PROPOSED SOCIAL WELFARE FACILITY (RESIDENTIAL CARE HOME FOR PERSONS WITH DISABILITIES) IN "VILLAGE TYPE DEVELOPMENT" ZONE ON APPROVED NAM SANG WAI OUTLINE ZONING PLAN NO. S/YL-NSW/10 AT LOTS 3669 S.A RP (PART), 3669 S.B RP (PART), 3670 RP (PART) AND ADJOINING GOVERNMENT LAND IN D.D.104, NAM SANG WAI, YUEN LONG

Town Planning Application No. A/YL-NSW/348 - Submission of Further Information (3)

**(Planning Application No. A/YL-NSW/348)
Response-to-Comment Table**

Figure Title **LENGTH OF VISIBILITY LINE FOR THE MOTORIST LEAVING THE PROPOSED RCHD AT KAM POK ROAD EAST**

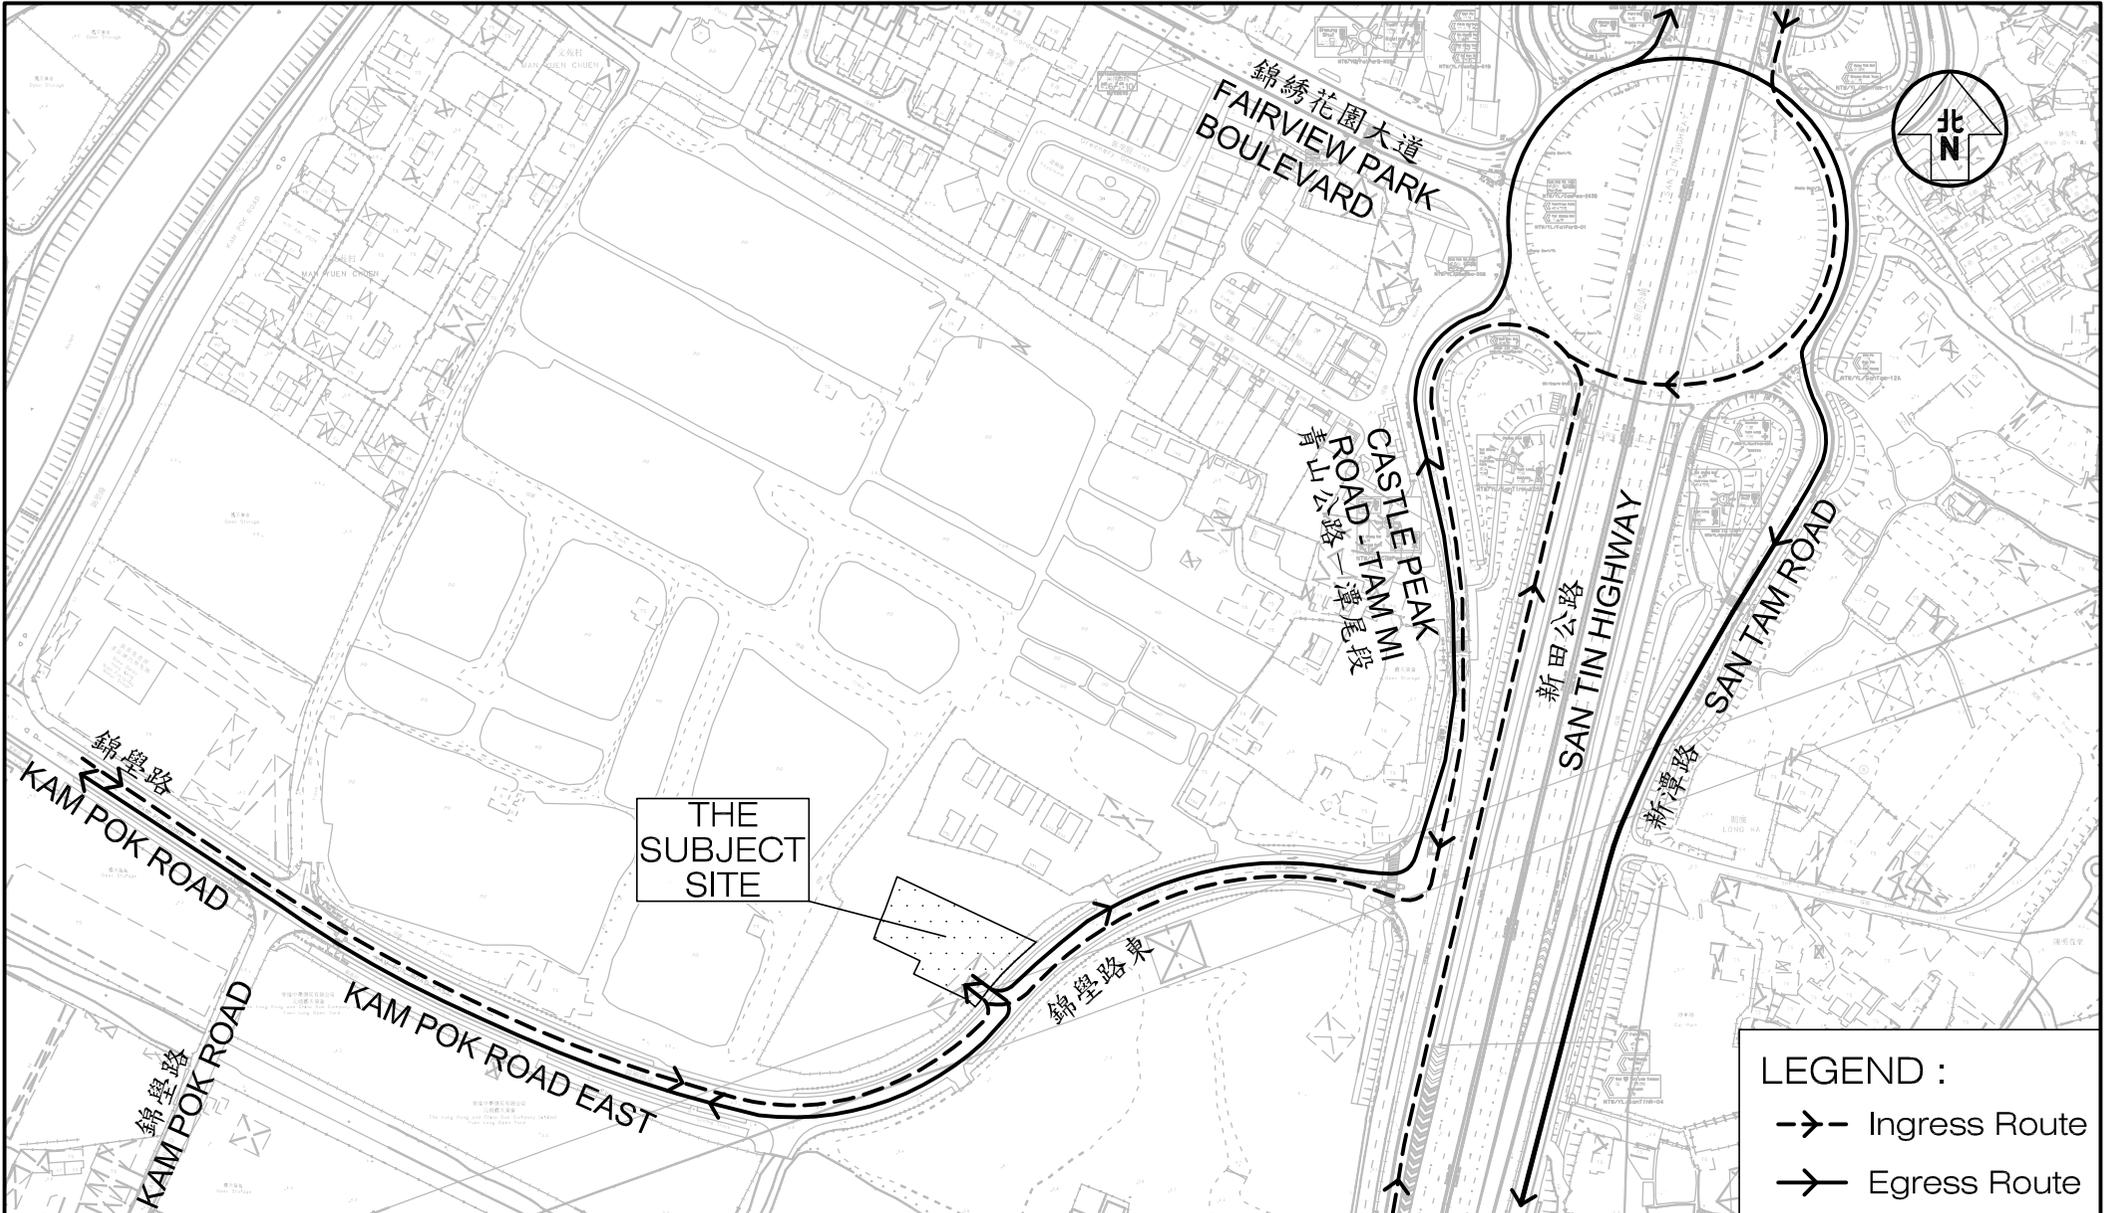
13. Re. RtC item 15: Please include the noise barrier on plan and revisit the visibility splay.

15. Please provide a plan to demonstrate sufficient sightline could be maintained at the proposed site access;	The measured length of visibility splay for the motorists leaving the Proposed RCHD is 60m to the left and 60m to the right, which is illustrated in Figure 3.3 in the revised TIA.

Noted. Please refer to the **Figure 3.3** in the revised TIA. The measured length of visibility splay for the motorists leaving the Proposed RCHD is 60m to the left and 60m to the right, so adequate sight line can be provided at the ingress/egress. The
